Docket Number:	00-AFC-02C
Project Title:	Mountainview Power Plant - Compliance
TN #:	242490
Document Title:	Statement of Staff Approval of Post Certification Change
Description:	N/A
Filer:	Marichka Haws
Organization:	California Energy Commission
Submitter Role:	Commission Staff
Submission Date:	3/29/2022 11:25:47 AM
Docketed Date:	3/29/2022

STATEMENT OF STAFF APPROVAL OF POST CERTIFICATION CHANGE

MOUNTAINVIEW GENERATING STATION (00-AFC-2C)

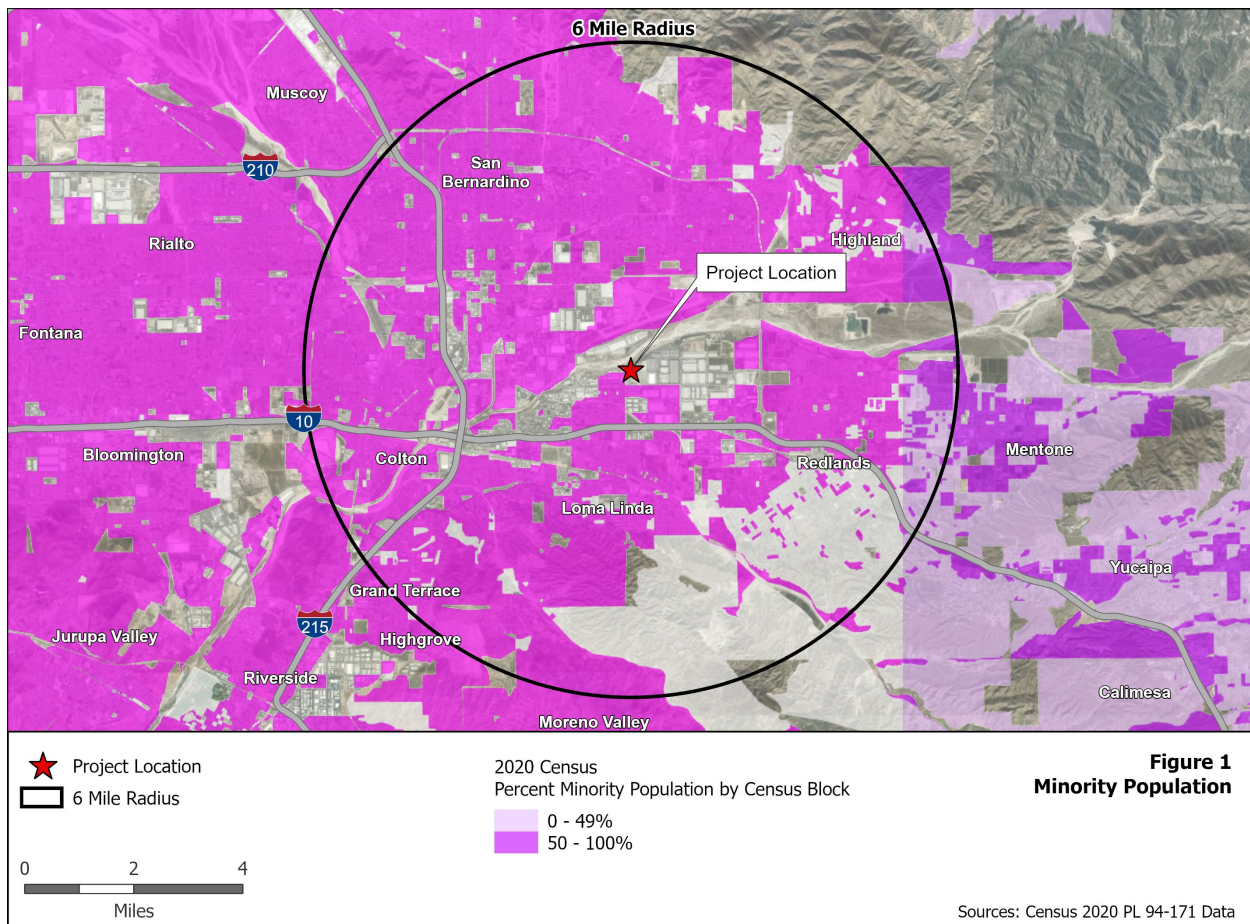
Environmental Justice – Figure 1 shows 2020 census blocks in the six-mile radius of the Mountainview Generating Station with a minority population greater than or equal to 50 percent. The population in these census blocks represents an environmental justice (EJ) population based on race and ethnicity as defined in the United States Environmental Protection Agency's *Guidance on Considering Environmental Justice During the Development of Regulatory Actions*. Staff conservatively obtains demographic data within a six-mile radius around a project site based on the parameters for dispersion modeling used in staff's air quality analysis. Air quality impacts are generally the type of project impacts that extend the furthest from a project site. Beyond a six-mile radius, air emissions have either settled out of the air column or mixed with surrounding air to the extent the potential impacts are less than significant. The area of potential impacts would not extend this far from the project site for most other technical areas included in staff's EJ analysis.

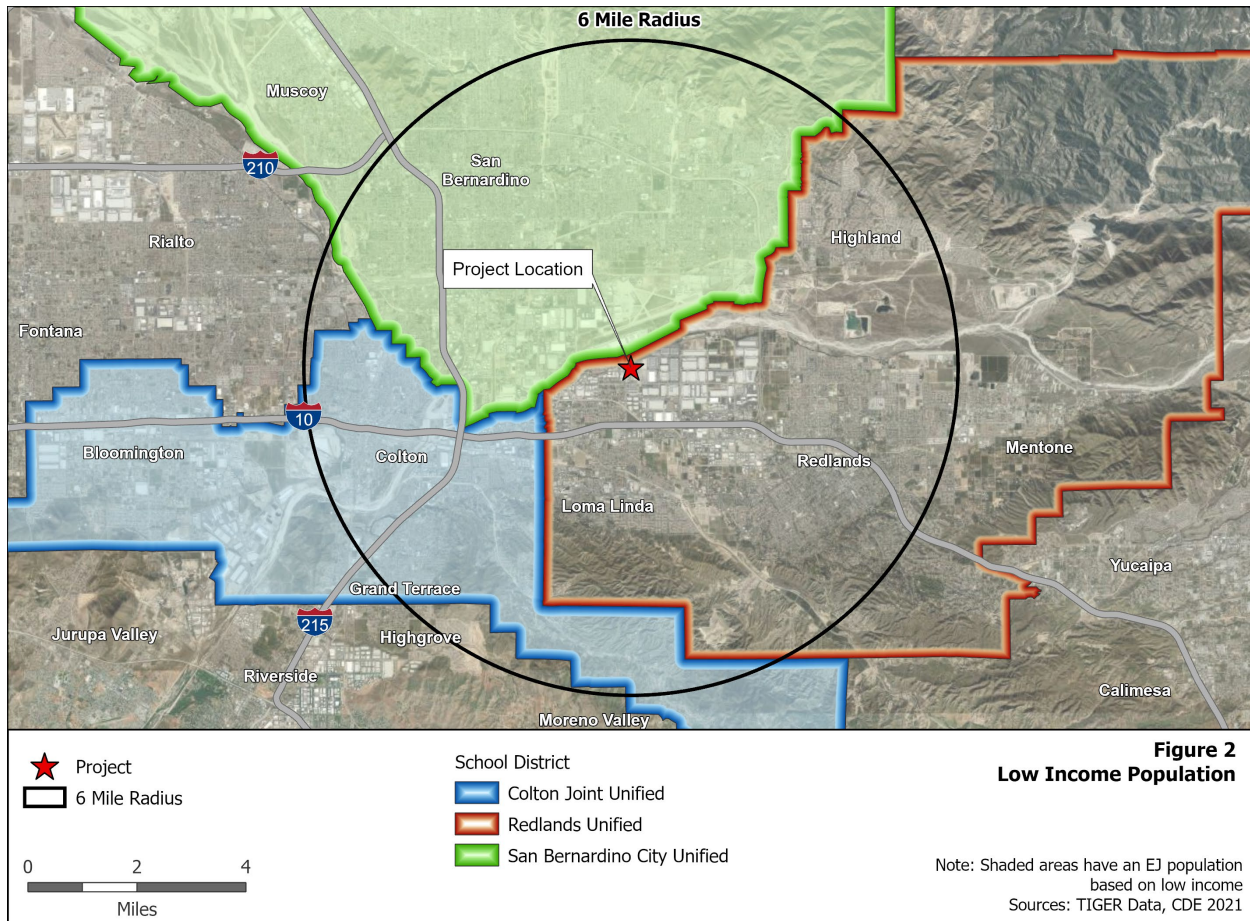
Based on California Department of Education data in the **Environmental Justice – Table 1**, staff concluded that the percentage of those living in the Colton Joint Unified and San Bernardino City Unified school districts (in a six-mile radius of the project site) and enrolled in the free or reduced-price meal program is larger than those in the reference geography. Thus, it is considered an EJ population based on low income as defined in *Guidance on Considering Environmental Justice During the Development of Regulatory Actions*. **Environmental Justice – Figure 2** shows where the boundaries of the school district are in relation to the six-mile radius around the Mountainview Generating Station site.
